**TOWN OF BROOKLYN
PLANNING AND ZONING COMMISSION
Regular Meeting Agenda
Wednesday, July 7, 2021 6:30 p.m.**

ENGINEERING PLAN REVIEW PERTAINING TO A 3-LOT SUBDIVISION (ASSESSOR'S MAP 41, LOT 85) PROULX STREET BROOKLYN, CT (April 30, 2021)

ENGINEERING PLAN REVIEW PERTAINING TO A 4-LOT SUBDIVISION CNG HOLDINGS, LLC (ASSESSOR'S MAP 42, LOT No. 32) DAY STREET BROOKLYN, CT (May 7, 2021)

Subdivision Plan "4 Lot Subdivision"

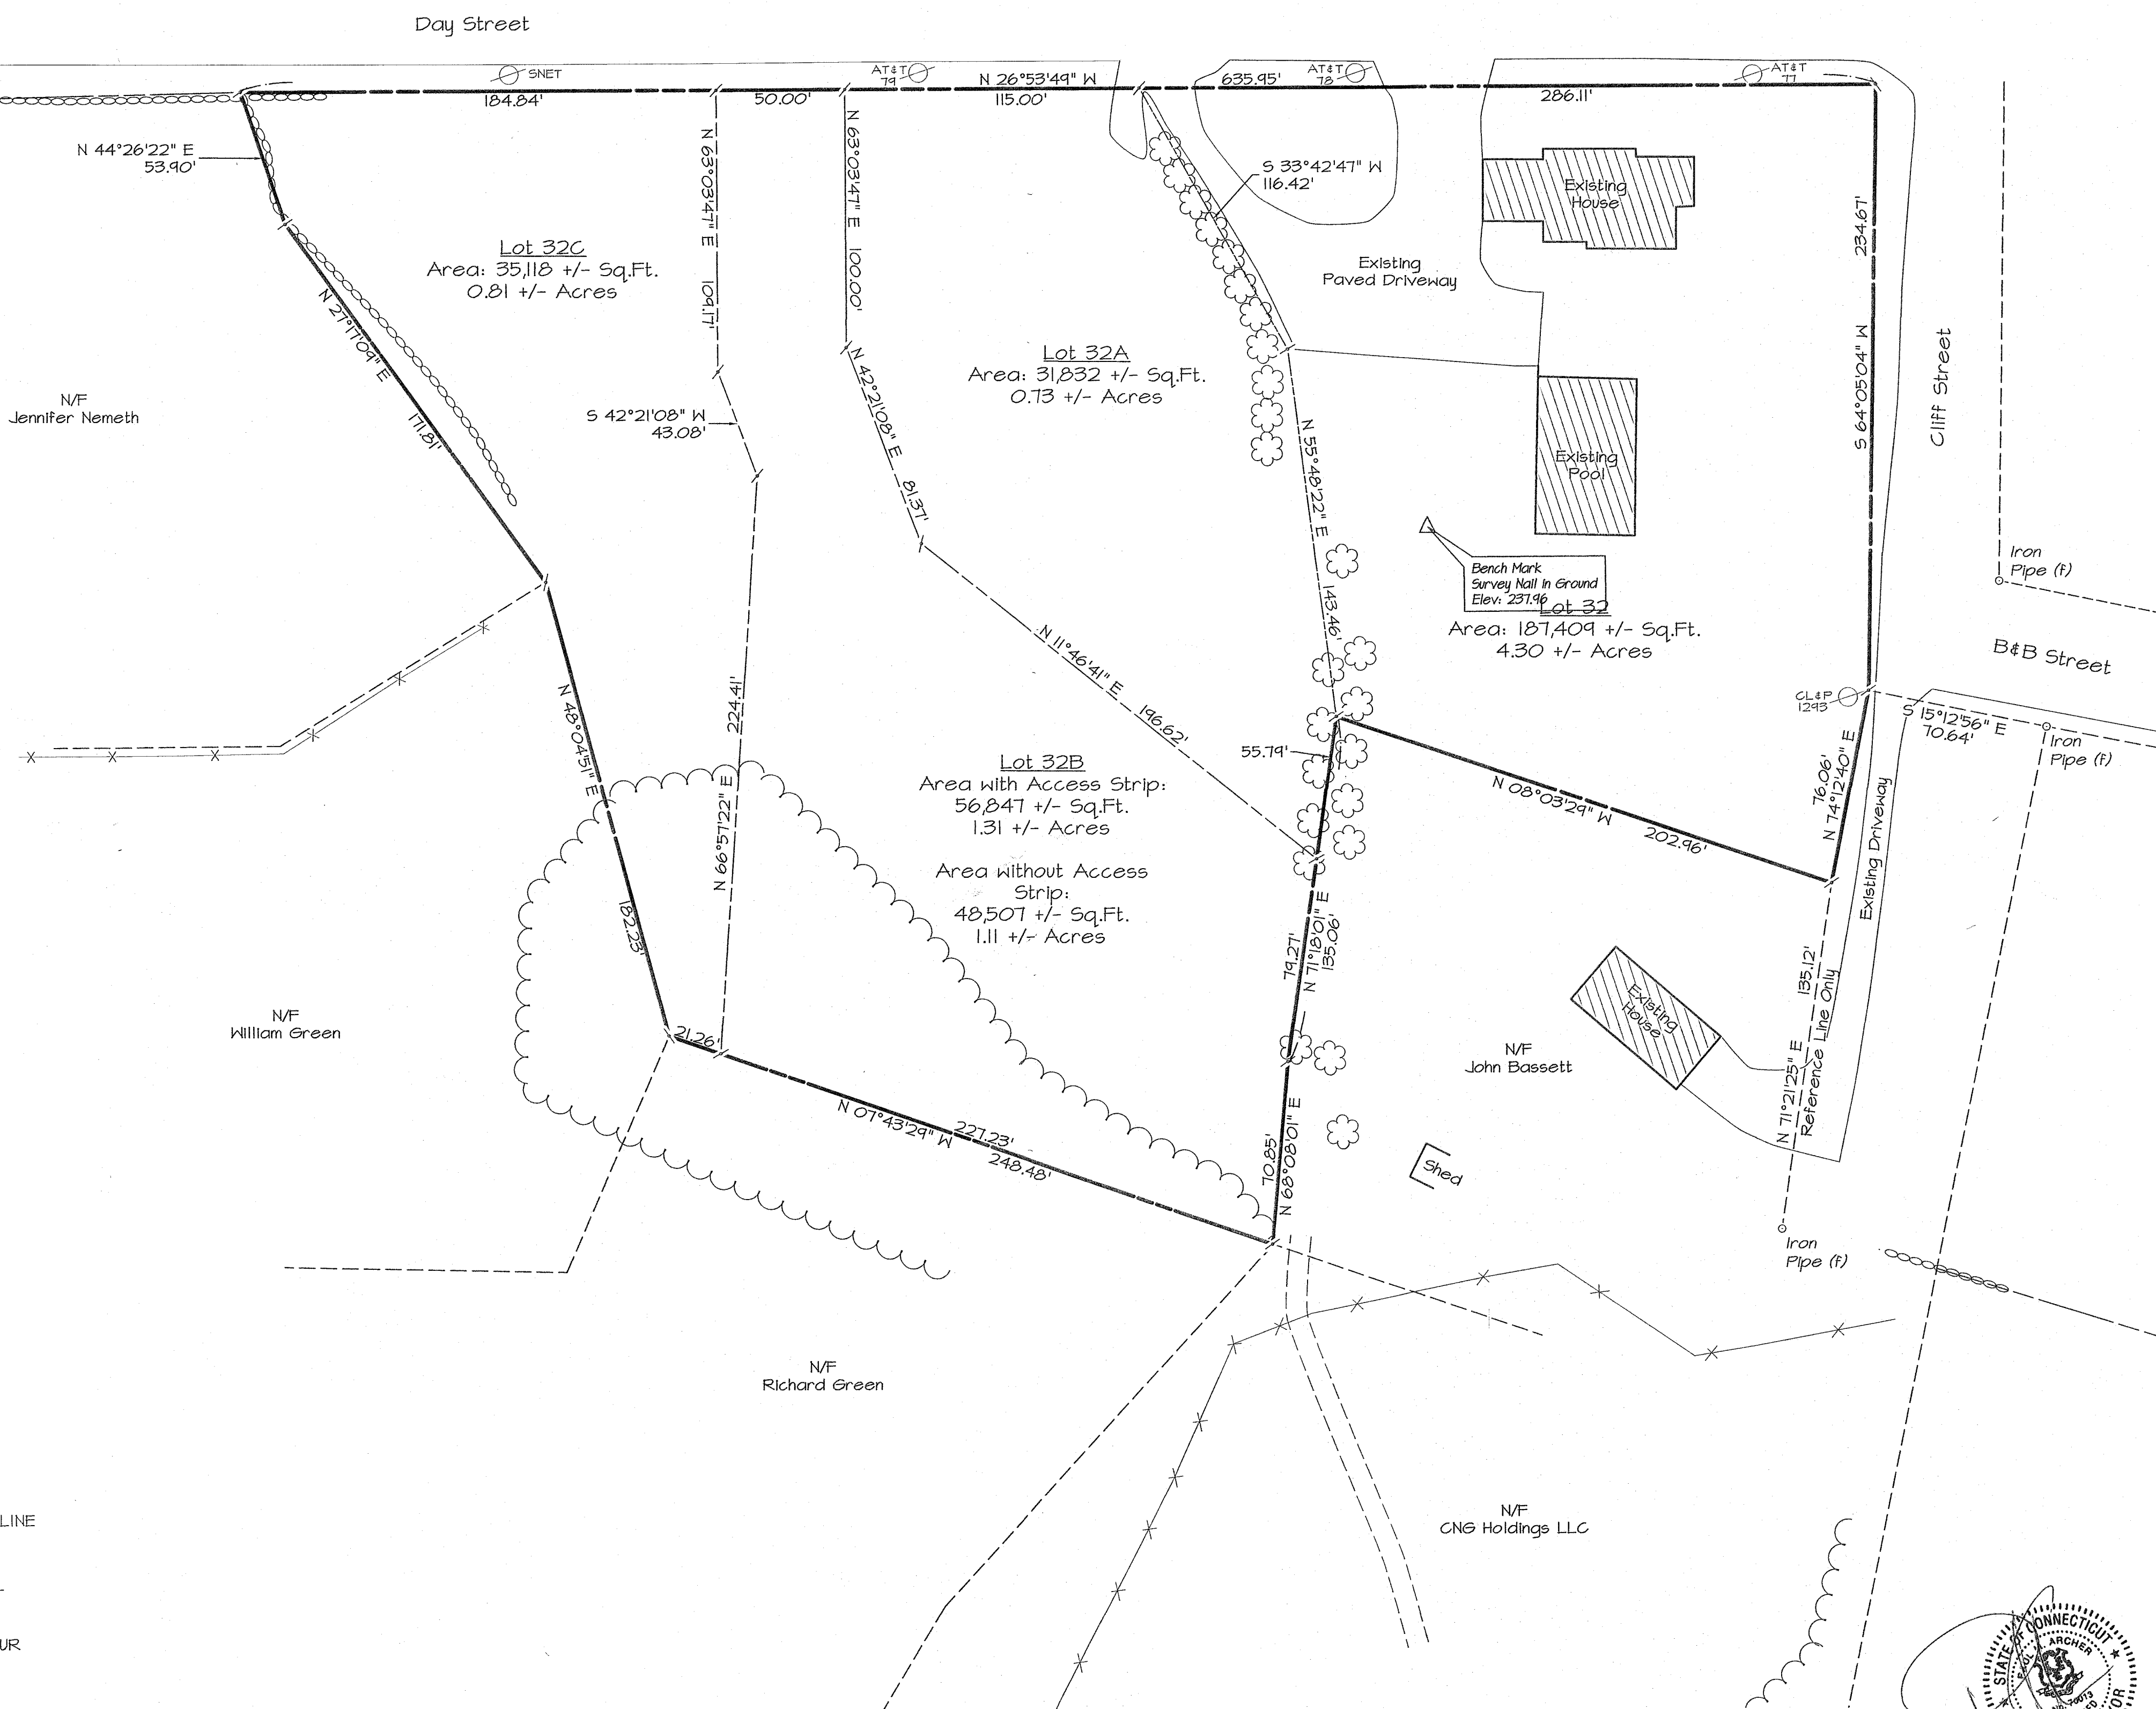
1. Zoning criteria is missing on this plan.
2. Note 1 under “Notes” does not include the accuracy of the topographic elevations shown on the plan. The accuracy needs to be included as part of this note.

REVISIONS	
5/10/2021	Revisions Per NECCOG Comments

1 05/11/21 VARIOUS MODIFICATIONS		CNG HOLDINGS, LLC		Project No. CLA-6736
No.	DATE	REVISION		Proj. Engineer R.A.D.
SUBDIVISION DAY STREET BROOKLYN, CT				Date: 04/21/21
GRADING AND SEPTIC DESIGN PLAN				Sheet No. 4 of 7

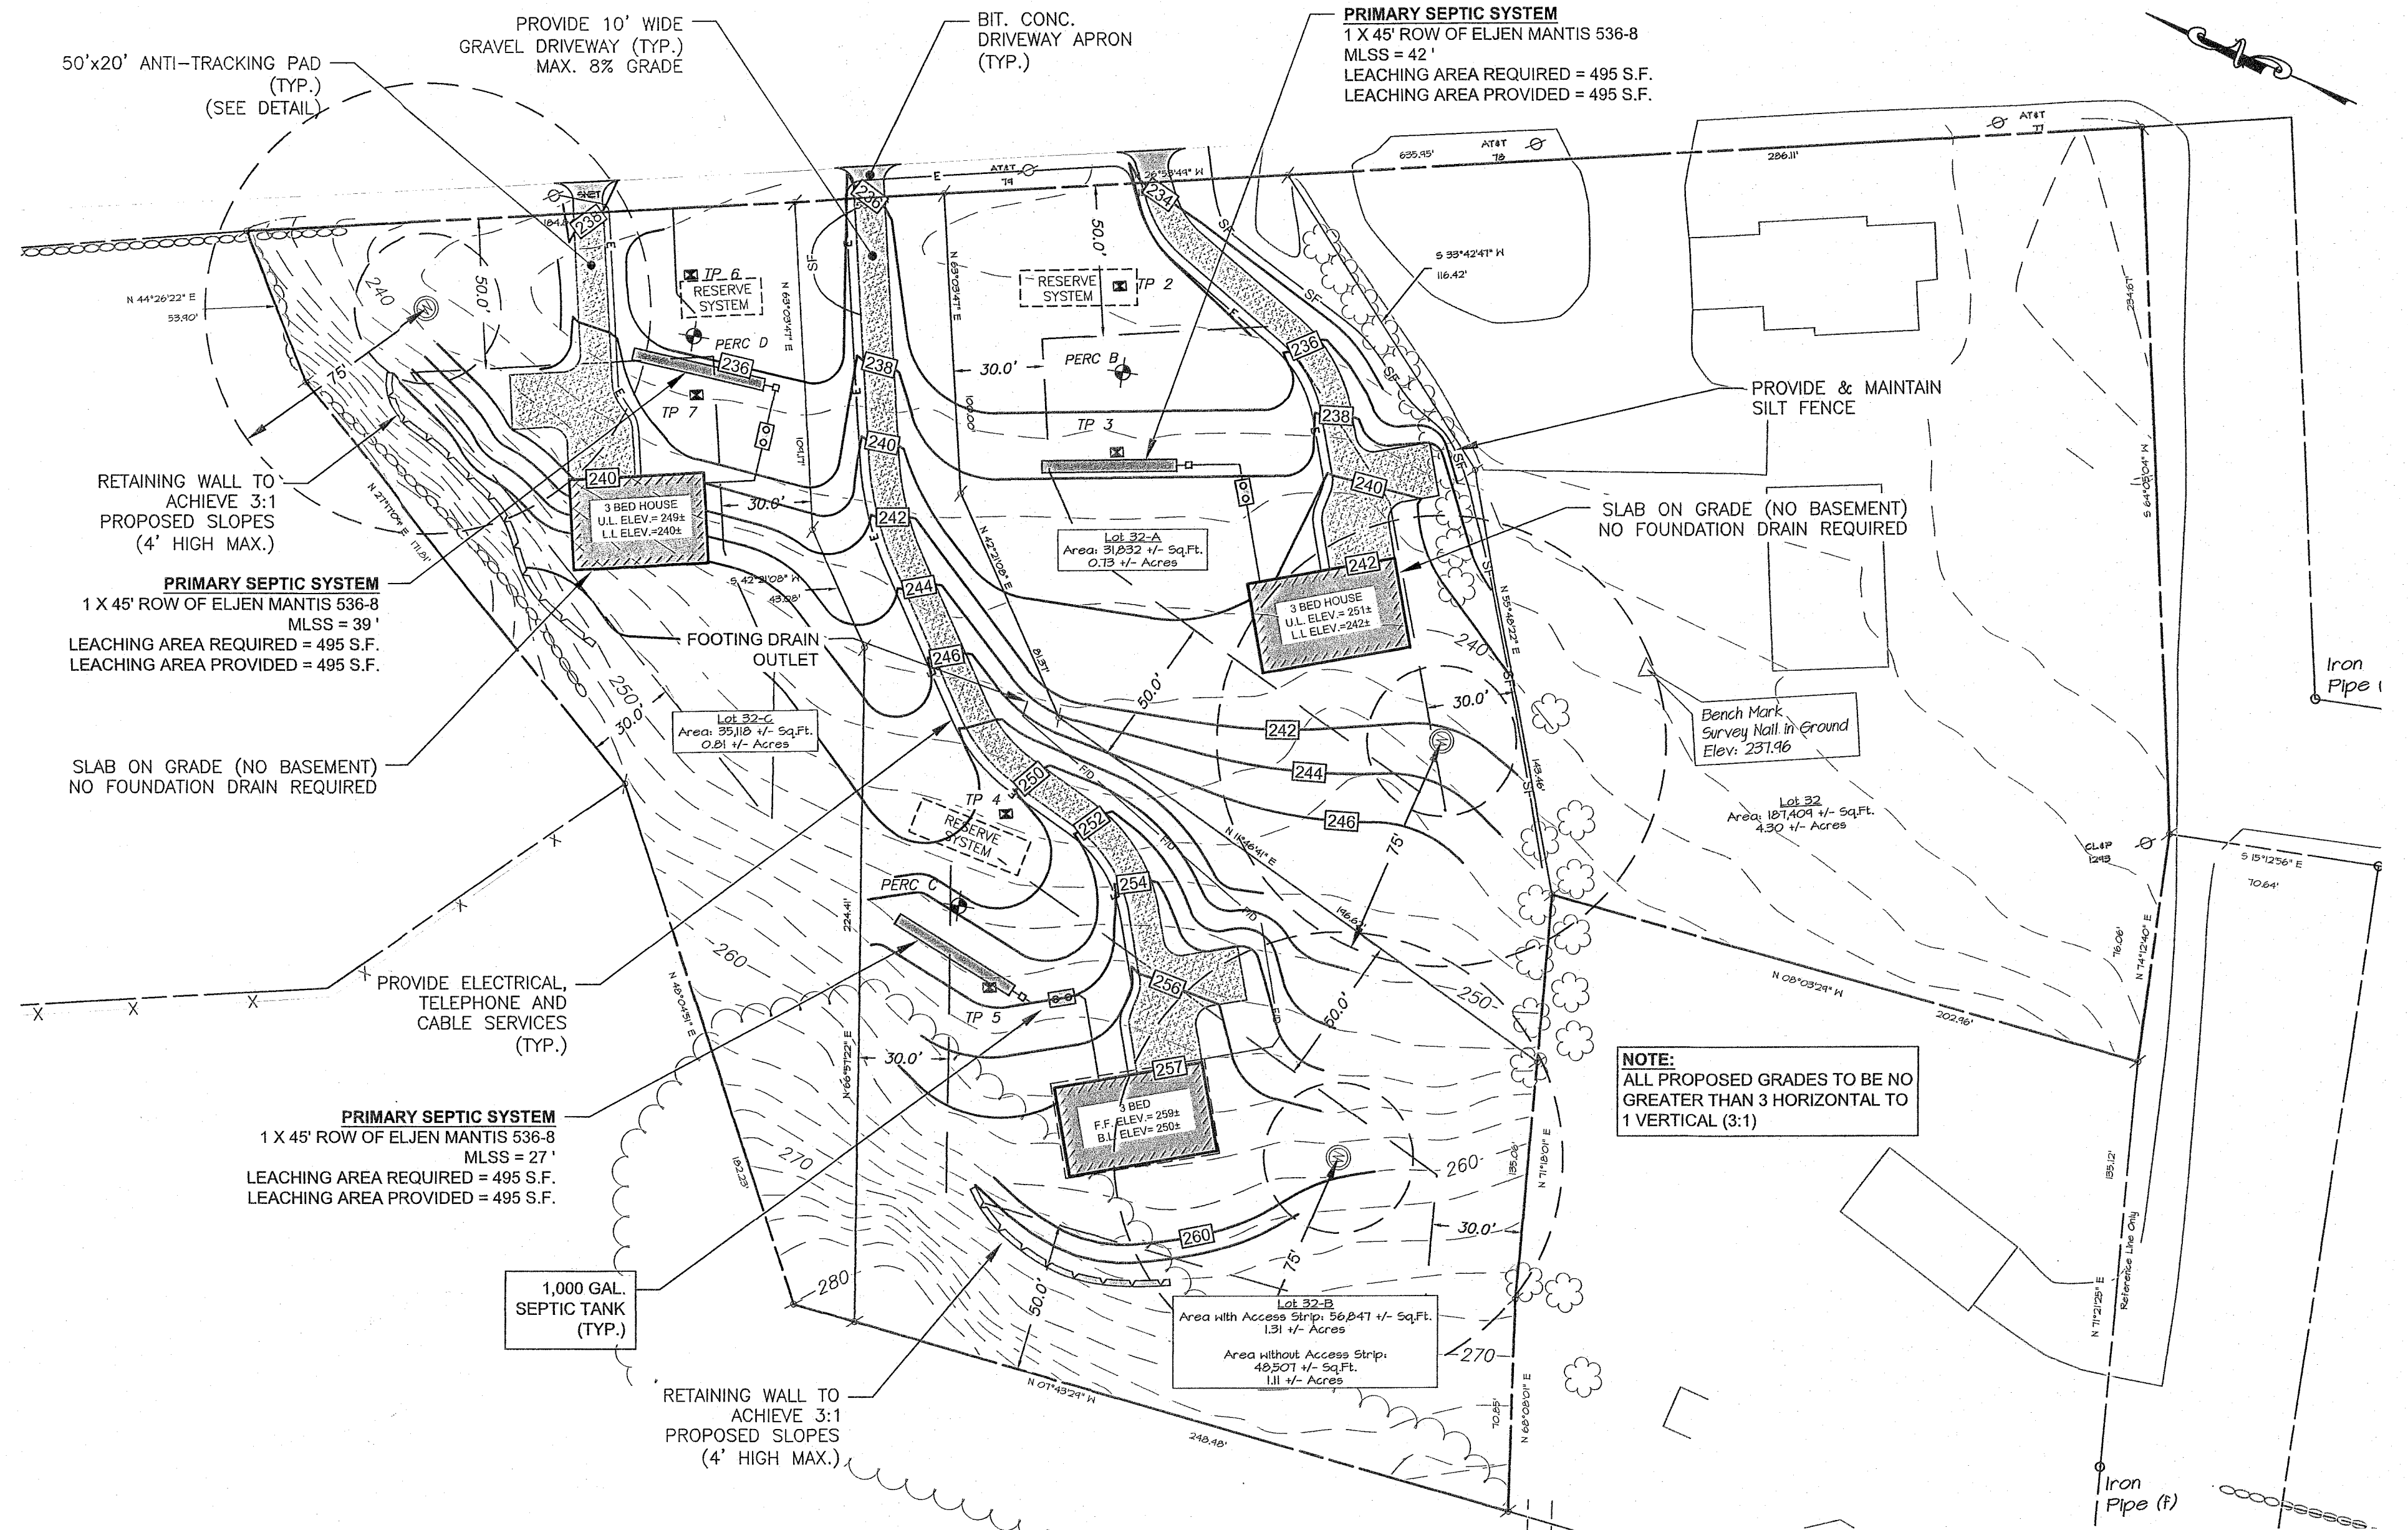
1. Note 1 under “Notes” does not include the accuracy of the topographic elevations shown on the plan. The accuracy needs to be included as part of this note.
2. A benchmark needs to be shown on the plan.

3. A silt fence, compost/silt sock and/or hay bale sediment control symbol needs to be included in the "Legend."
4. The slopes around the west side of the house footprint on Lot 32-C and need to be changed to no steeper than 3:1. If this cannot be met, a retaining wall will need to be designed for this location in order to provide adequate clearance around the house, especially in consideration of firefighting.

7. A note needs to be placed on the plan stating that no slopes greater than 3:1 are allowed.
8. All angle points in the property lines are to be marked with detectable markers, e.g. iron pins, with a symbol placed in the "Legend."

9. All front, side yard and rear yard setbacks are to be labeled on the plan.
10. Paved driveway aprons need to be shown on the plan

TYPICAL SERVICE PIPE TRENCH DETAIL
NOT TO SCALE

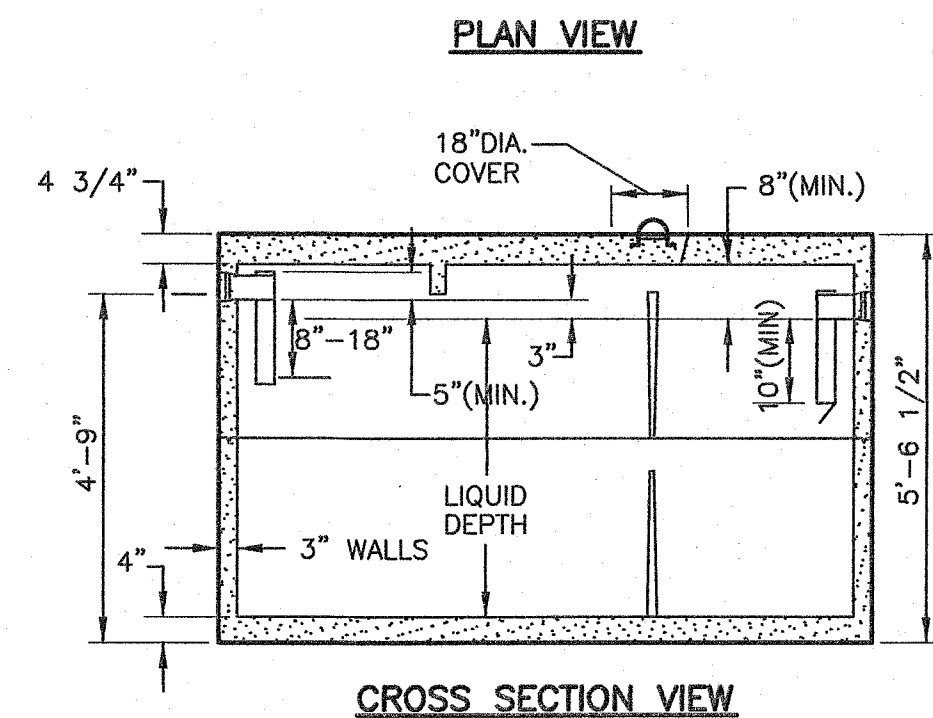
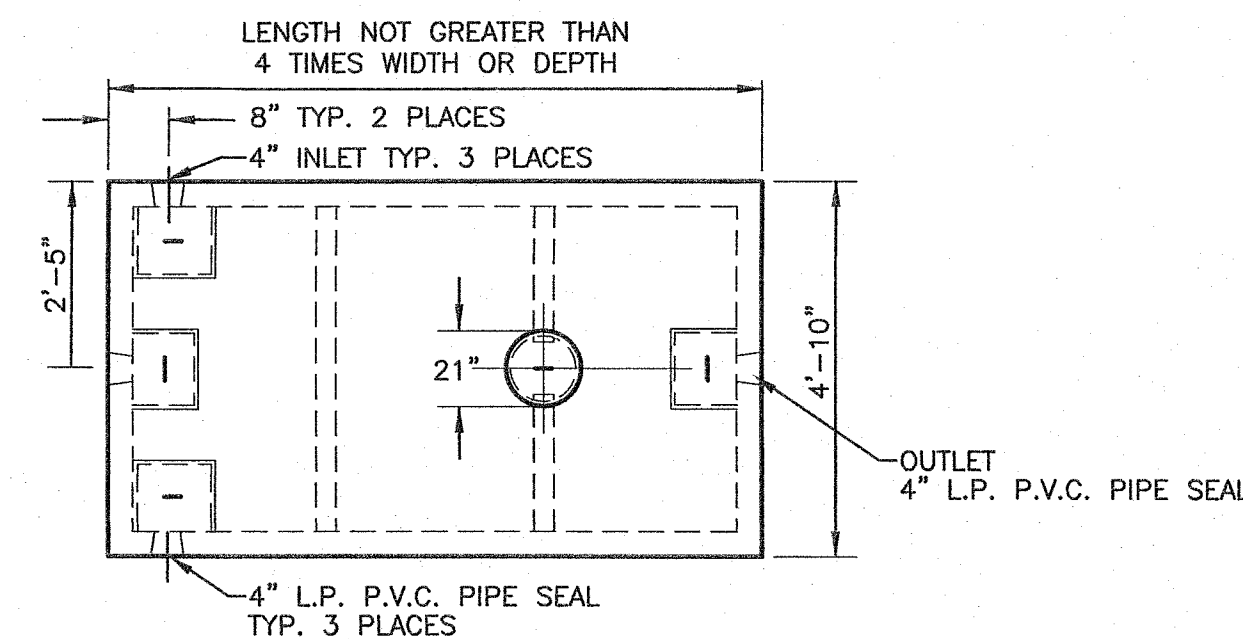
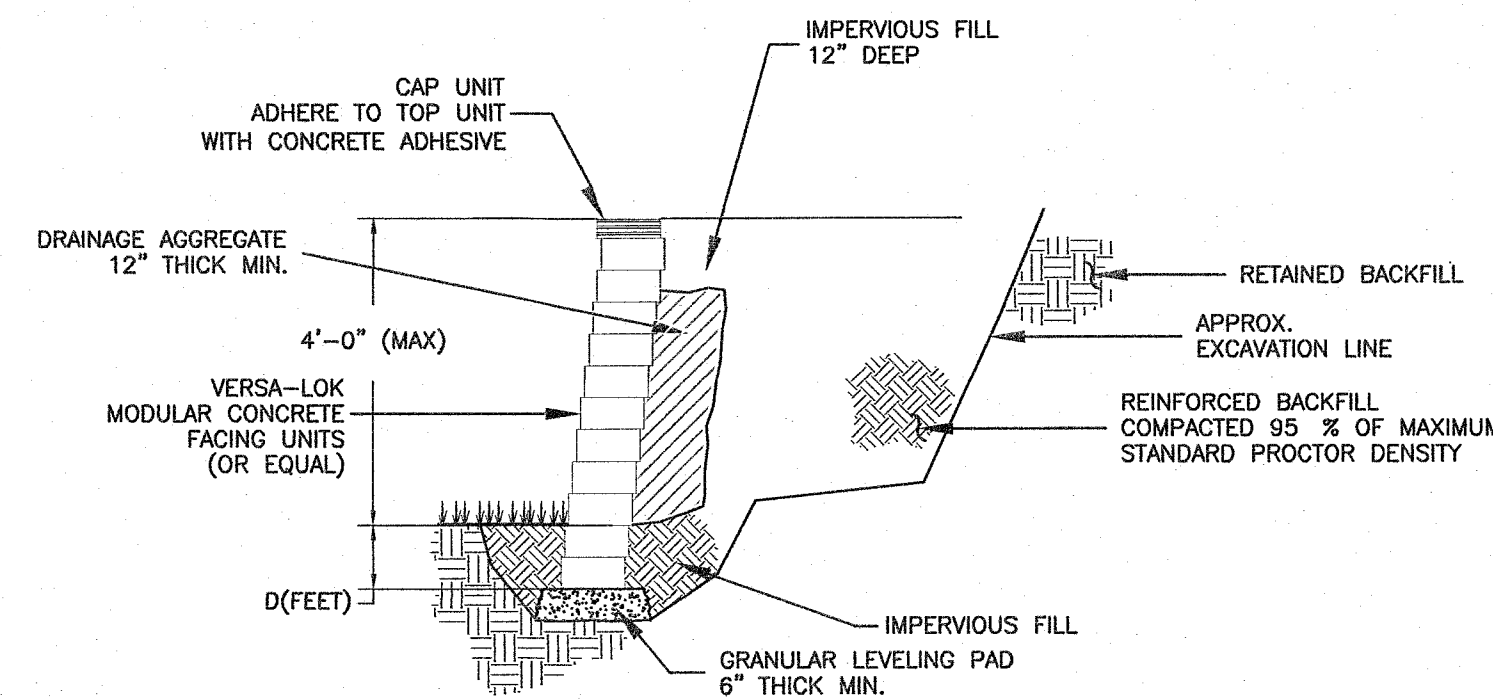
1. Any reference to CT DOT Form 816 is to be changed to the current Form 818 designation.
2. A detectable warning tape needs to be shown over the pipes in "The "Trench Detail: Sanitary Sewer Service" and "Typical Service Pipe Trench Detail."
3. A paved driveway apron detail needs to be included on this plan.
